SUBJECT: RESOLUTION OF B-56, "DIESEL GENERATOR RELIABILITY"

Purpose: Discussions Related to RG. 1.9, Revision 3 (Proposed)

The 10-5-89 working draft of Regulatory Guide 1.9, Revision 3 (enclosed) represents near culmination of these meetings with NUMARC's B-56 working group. The enclosed markups highlight the results of the October 6, 1989 meeting.

Figure 1 Graded Response to Degrading EDG Reliability

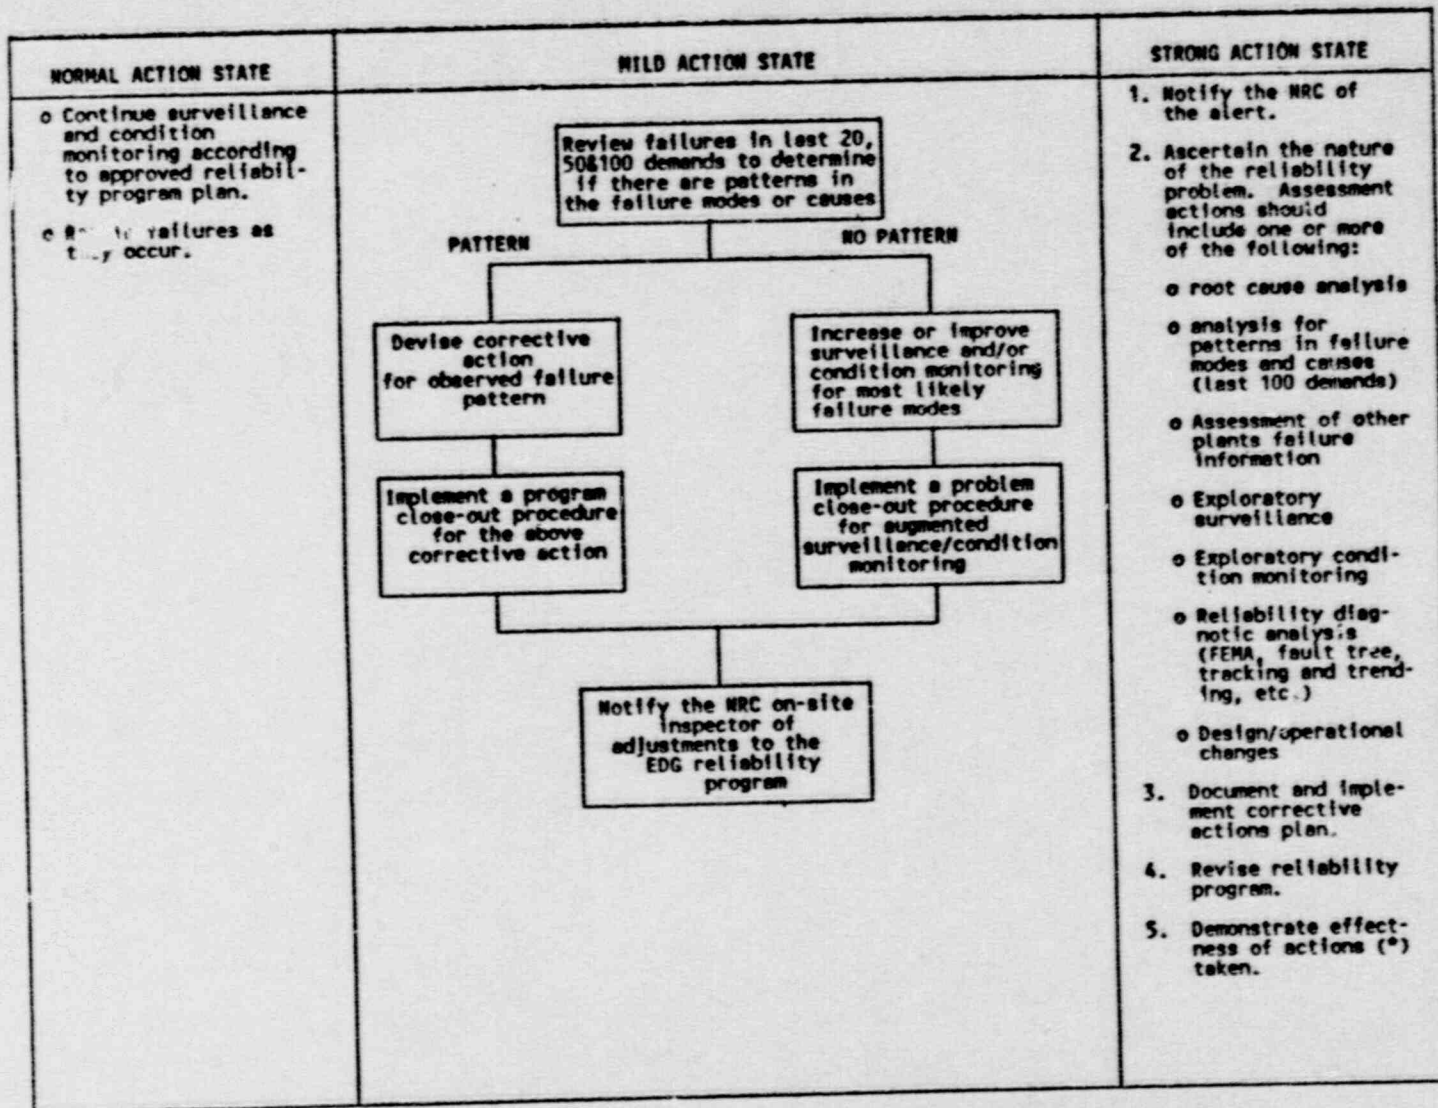
(10-9-89 Draft)

* Recovery actions are discussed in Regulatory Positions C.3.5 and C.2.3.3.
